**PLANNED UNIT DEVELOPMENT
& SUBDIVISION STAFF REPORT****Date: December 20, 2007****DEVELOPMENT NAME**

Perch Creek Preserve

Planned Unit Development Approval to allow a gated, 18'-wide, aggregate- surfaced private street single-family residential subdivision with reduced lot widths and sizes, reduced front and side setbacks, and increased site coverage of 50%.

SITE PLAN

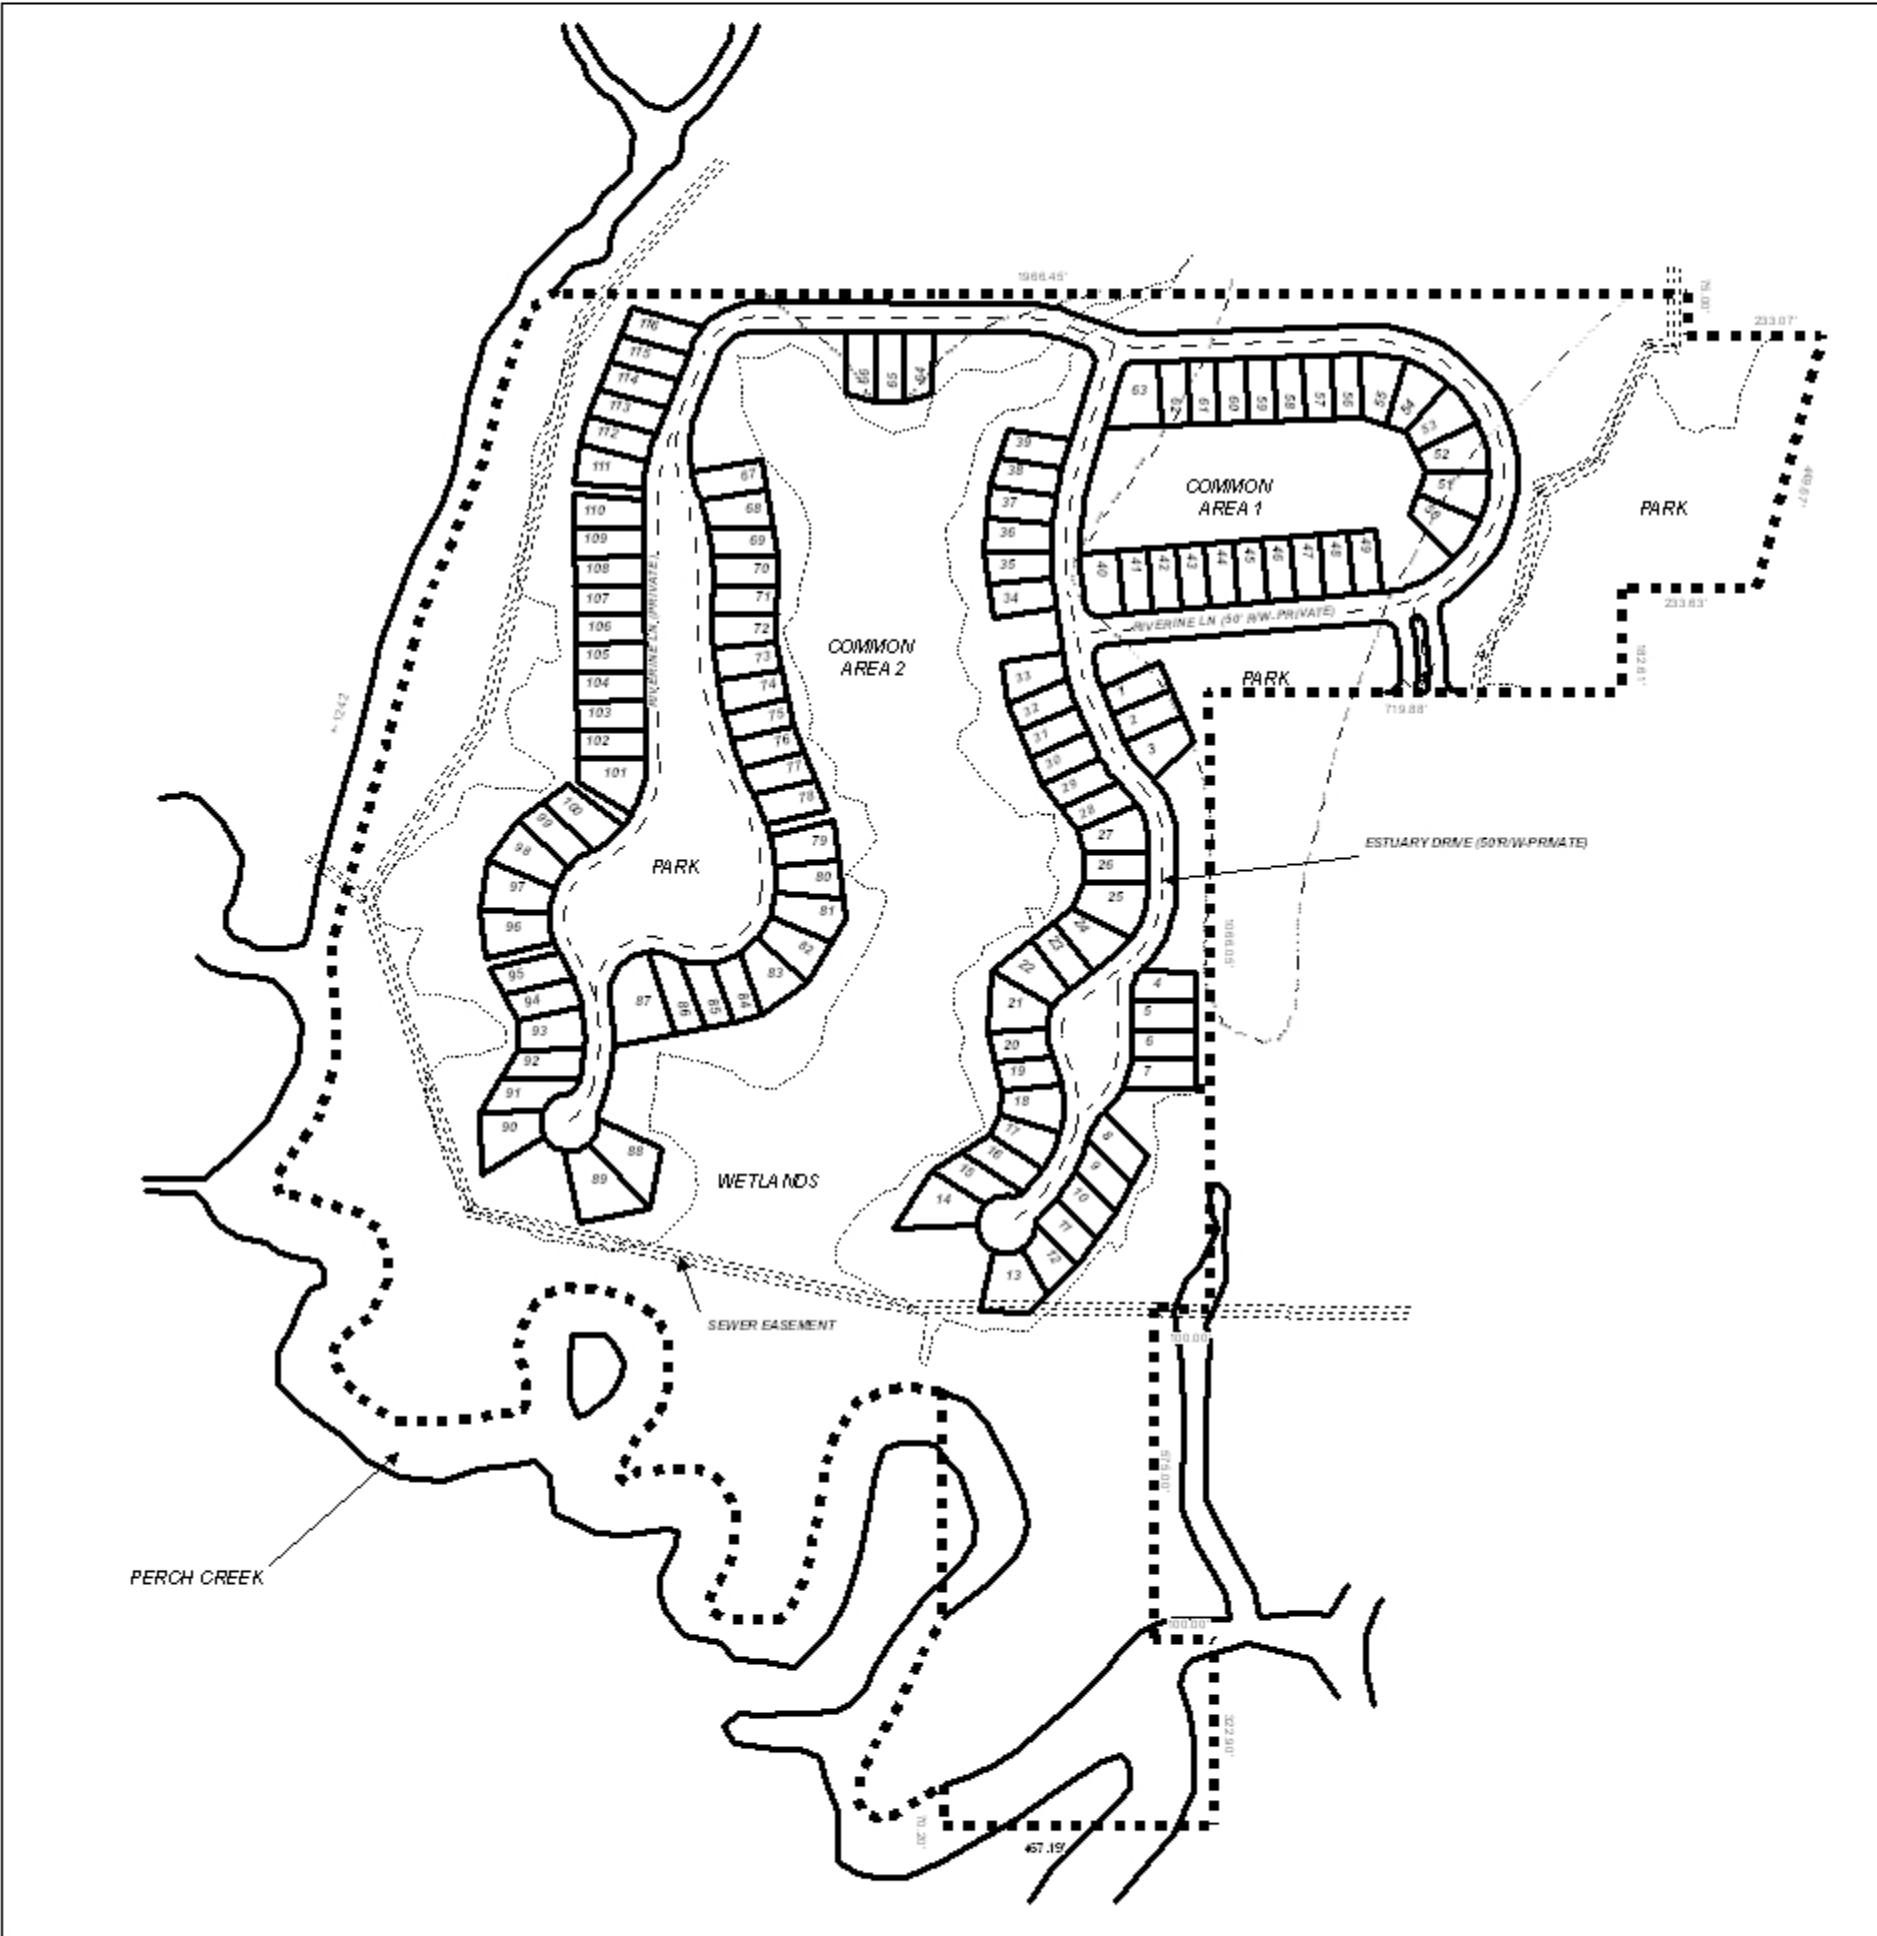
Another issue is that the locations of the one-way and two-way surfaces are not shown on the plan, nor are the areas intended for asphalt or pavers. PUD Approval is site plan specific, therefore the plan should reflect the locations of the one-way and two-way surfaces, and the paving sections.

The plan denotes several areas as "PARK" and others as common area. Neither the narrative nor the plan reference the difference between the two, nor whether the "parks" are to be private or dedicated parks.

4. Revise the plat to illustrate locations of one-way and two-way surfacing, and areas of asphalt paving or pavers;
5. submit justification for aggregate surfacing in lieu of paved surfacing as required by the Subdivision Regulations;

6. Revise the plan to illustrate areas of clearing and/or improvements within the park areas illustrated in the private street rights-of-ways;
7. provide information regarding the areas denoted as "Park", explaining the difference between "Park" and "Common Area", and if the "parks" are to be private or dedicated parks;

- 6) Revise the plan to illustrate areas of clearing and/or improvements within the park areas illustrated in the private street rights-of-ways;
While the majority of the common areas are noted as "Natural Area", the common areas within the private road right-of-way are so noted, nor is information provided to indicate if these area are to be cleared or maintained in a natural state.

The plan has been revised to eliminate the term "Park", labeling all such areas as "Common (Natural Area)". The narrative references areas being preserved as common areas with careful use restrictions. Other common areas are specific noted are remaining natural with only select clearing for nature trails.

- 4) Revise the plat to illustrate locations of one-way and two-way surfacing, and areas of asphalt paving or pavers;
As stated above, one-way design has been eliminated, and the plat has been revised to illustrate proposed locations of asphalt paving or pavers.

Subdivision: Based upon the preceding, it is recommended that this application be considered under the Innovative Section of the Subdivision Regulations, be approved as a gated private road subdivision, and that Section VIII.E.2.c be waived to allow 20' wide aggregate surfacing as illustrated on the revised plat submitted, subject to the following conditions:
